**SUBJECT:** R.E. Ginna Nuclear Power Plant  
Docket No. 50-244

**Supplemental Response to Requests for Additional Information Regarding  
Topics Described by Letters Dated August 24, 2005 and October 28, 2005**

ATTACHMENT 2  
RESPONSES TO NRC RAIs 2, 3, 5 REGARDING POST-LOCA LONG-TERM COOLING  
OCTOBER 28, 2005

ATTACHMENT 3  
RESPONSES TO NRC RAIs REGARDING LOCA ANALYSES  
AUGUST 24, 2005

**Figure 1 Large Break LOCA Boric Acid Concentration Analysis - Core/Upper Plenum  
Average Void Fraction versus Time**

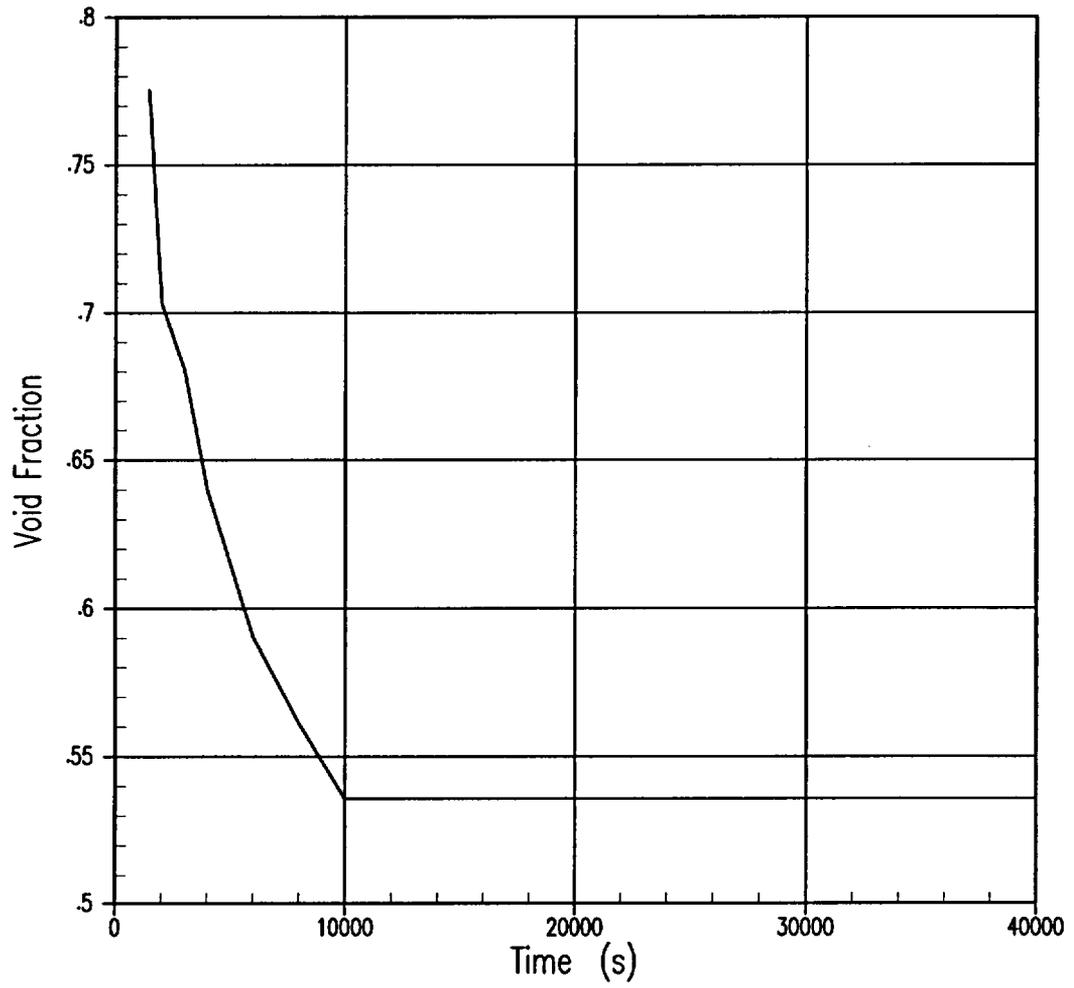
Items a) and b) above satisfy the NRC request to consider void fractions and system effects in the calculation of core mixing volume (Post-LOCA LTC RAI#1[a,b]). The significant assumptions in the large break boric acid precipitation calculations are as follows:

1. The core region mixing volume is limited to the region from the bottom of the active fuel to the bottom elevation of the hot legs plus 50% of the lower plenum (justified in Reference 1) volume (the region from the bottom of the active fuel to the bottom of the reactor vessel). Hot leg volume or barrel/baffle/former region volumes are not included.
2. Core boiloff rates are obtained in part from the Ginna WCOBRA/TRAC Large Break LOCA Evaluation Model computer runs. The core boiloff rate used in the calculations is given in Figure 3.
3. Time-based liquid mixing volume is extracted from the Ginna WCOBRA/TRAC Large Break LOCA Evaluation Model computer runs. The core and upper plenum average voiding assumed in the analysis is given in Figure 1. The associated mixing volume used in the calculations is given in Figure 2.
4. The calculations were based on a vessel pressure of 14.7 psia.

**Figure 3 Large Break LOCA Boric Acid Concentration Analysis - Vessel Boric Acid Concentration / Boiloff and Dilution Flow versus Time**

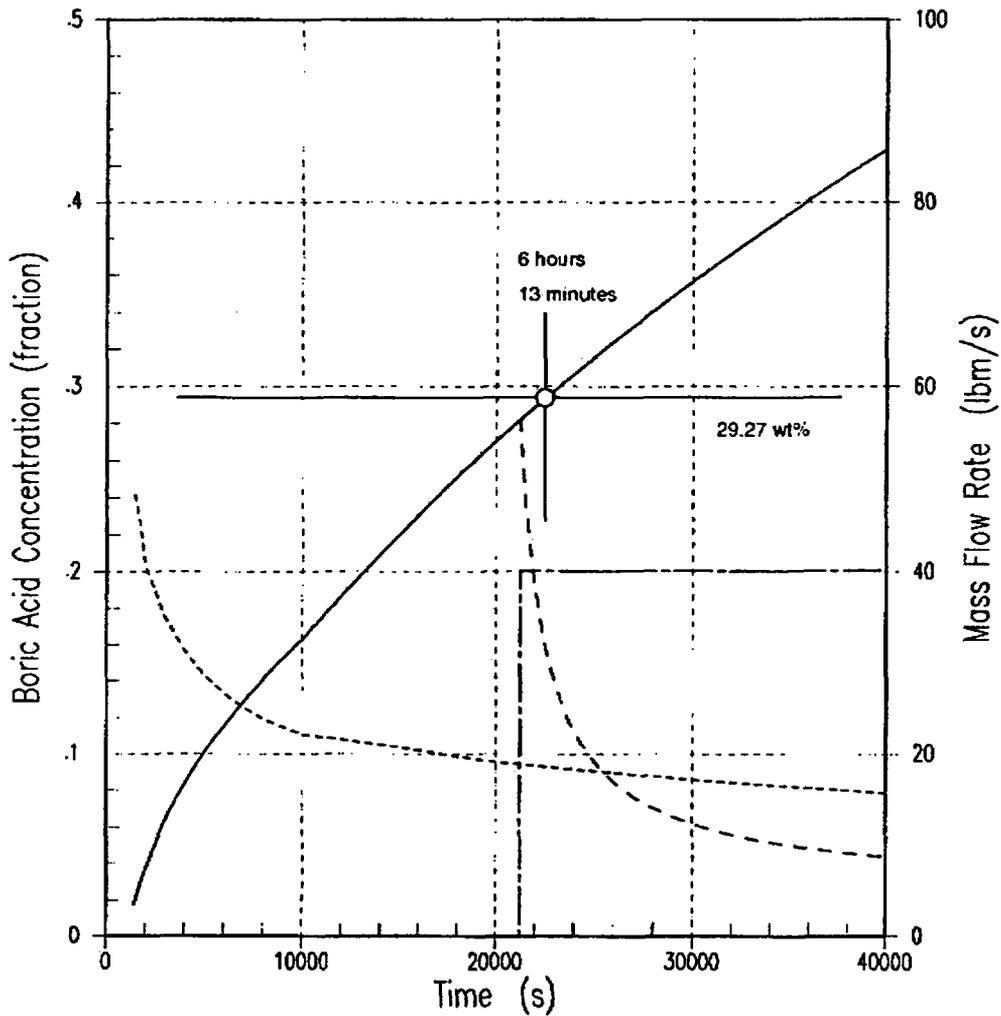
There were no quantitative analysis results supplied justifying the operator action time to reinstate cold-side injection to control boric acid precipitation following a LOCA. No boron concentration vs. time curves were provided for the limiting breaks. No analyses of breaks where the reactor coolant system pressure remains above the residual heat removal pump shut off head were provided nor was the effect of the timing for reinitiating cold-side injection identified to show sufficient time exists to control boric acid concentration for small breaks. The margin in flushing flow was not identified nor was the time needed to turn around the boric acid concentration once flushing begins. The detail of how the boron concentration was calculated was also not provided.

The minimum injection temperature and maximum boron concentration in the core was not identified to demonstrate that precipitation is precluded at the time to activate cold-side injection. The 1975 methods cited in the submittal for calculating boric acid concentration contain many unsubstantiated assumptions. See the Westinghouse-CE Topical Report CENPD-254 as an example of the analysis methods and results needed in order to complete the review of long-term cooling performance.

The results of the large break boric acid precipitation calculations are shown in Figure 3. As seen in Figure 3, for large hot leg breaks with no cold leg safety injection during an extended period in sump recirculation, boric acid precipitation will be prevented if cold leg safety injection (i.e. simultaneous injection) is re-established 5 hours, 49 minutes after the termination of safety injection in the cold leg. This is based on a calculated minimum time to terminate SI to the cold leg of 24 minutes after the break. Figure 3 also shows core boil-off, SI dilution flow, and the rate of dilution of core region if dilution flow is initiated at 5 hours, 30 minutes after the earliest expected termination of cold leg safety injection.

Figure 4 Small Break LOCA - 4-inch Break RCS Depressurization Without Operator Actions

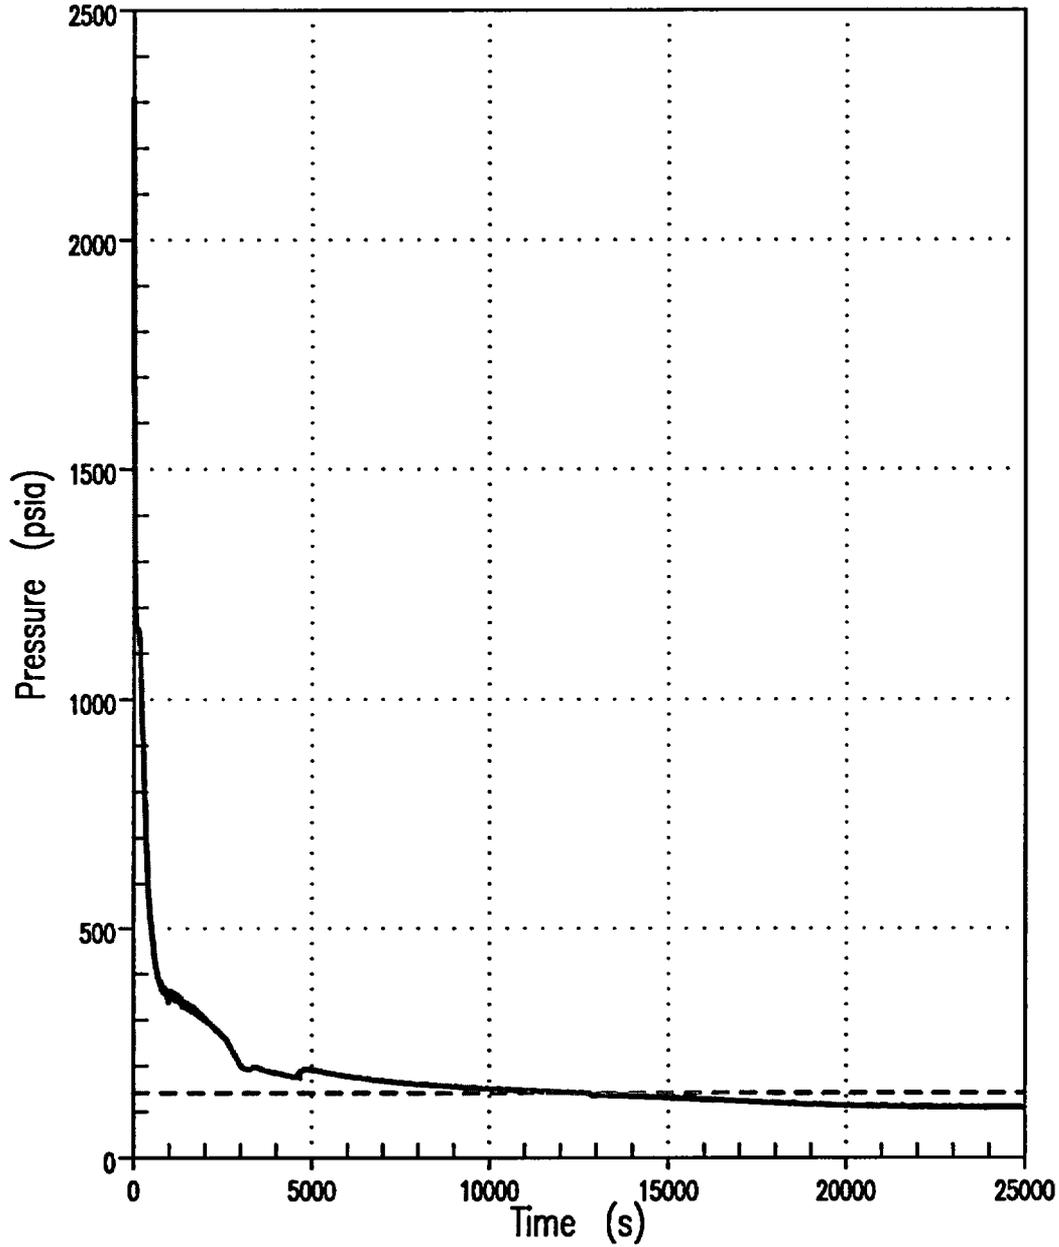
3. Provide information to show that for the largest break that does not actuate upper plenum injection (UPI) (where a cooldown is required) that there is sufficient time to perform this function given an appropriate precipitation time based on consideration of the four items in item 1 above.

A Ginna EPU NOTRUMP Small Break Post-LOCA Cooldown Analysis showed that a 4 inch break or greater will depressurize the RCS to the UPI cut-in pressure without operator actions prior to reaching the boric acid atmospheric solubility limit (see discussion in Attachment A). For smaller breaks down to approximately 1.1 inches, the operators will depressurize the RCS in accordance with Emergency Procedure ES-1.2, Post LOCA Cooldown and Depressurization. The Small Break LOCA Boric Acid Analysis and the small break cooldown analyses described in Attachment A demonstrate that the plant will be depressurized and dilution flow will flush the core prior to the atmospheric solubility limit being reached.

The Small Break LOCA Boric Acid Analysis was based on calculations that used a time-varied mixing volume and core boil-off extracted from extended Ginna NOTRUMP Small Break LOCA Evaluation Model computer runs. A 4 inch break was selected since the Ginna EPU NOTRUMP Small Break Post-LOCA Cooldown Analysis (discussed in the next section) showed that a 4 inch break or greater will depressurize the RCS to RHR cut-in pressure without operator actions prior to reaching the boric acid atmospheric solubility limit. The RCS pressure versus time for a 4 inch break is given in Figure 4. The modeling features of these runs were as follows:

**Figure 5 Small Break LOCA Boric Acid Concentration Analysis - Core/Upper Plenum  
Average Void Fraction versus Time**

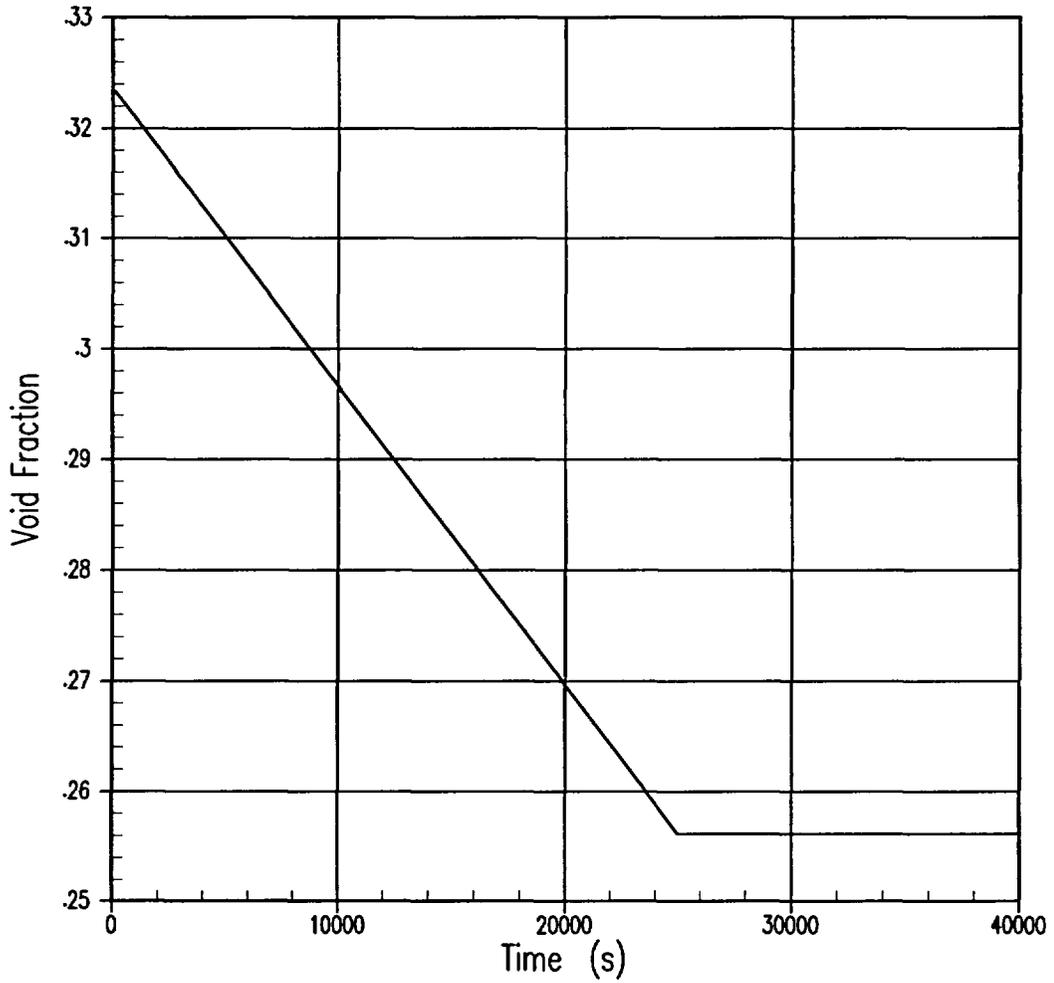
Item a) above satisfies the NRC request to consider void fractions and system effects in the calculation of core mixing volume (Post-LOCA LTC RAI#1[a,b]). The significant assumptions in the small break boric acid precipitation calculations are as follows:

1. Time-based liquid mixing volume and core boiloff rates are extracted from the Ginna NOTRUMP Small Break LOCA Evaluation Model computer runs. The core and upper plenum average voiding assumed in the analysis is given in Figure 5. The associated mixing volume used in the calculations is given in Figure 6.

**Figure 7 Small Break LOCA Boric Acid Concentration Analysis - Vessel Boric Acid Concentration / Bolloff and Dilution Flow versus Time**

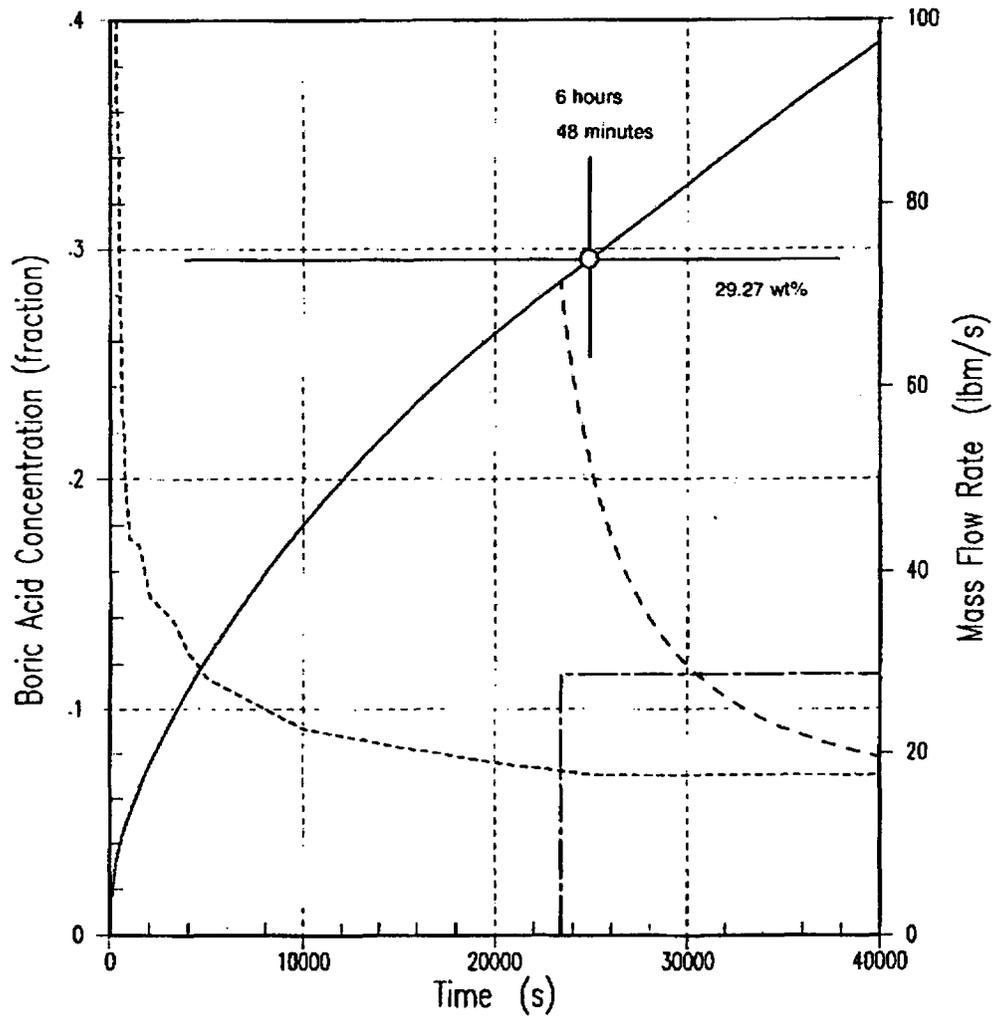
2. Small breaks were not addressed. The boric acid concentration for the limiting SBLOCA needs to be evaluated. Provide a summary of the results to show that the boric acid concentration is not sufficient to cause precipitation should the operators inadvertently depressurize the reactor coolant system (RCS) in a rapid manner.

The results of the small break boric acid precipitation calculations are shown in Figure 7. As seen in Figure 7, for small breaks where delayed RCS depressurization would occur, the boric acid solution will not approach the solubility limit until approximately 6 hours, 48 minutes after the break. If the RCS is depressurized through operator action to below 140 psia, UPI using the RHR (low head SI) pumps will initiate and this will provide immediate core flushing flow. Cooldown/depressurization calculations show that operators could depressurize the RCS to less than 140 psia long before 6 hours, 48 minutes. Figure 7 also shows core boil-off, SI dilution flow, and the rate of dilution of core region once dilution flow is initiated.
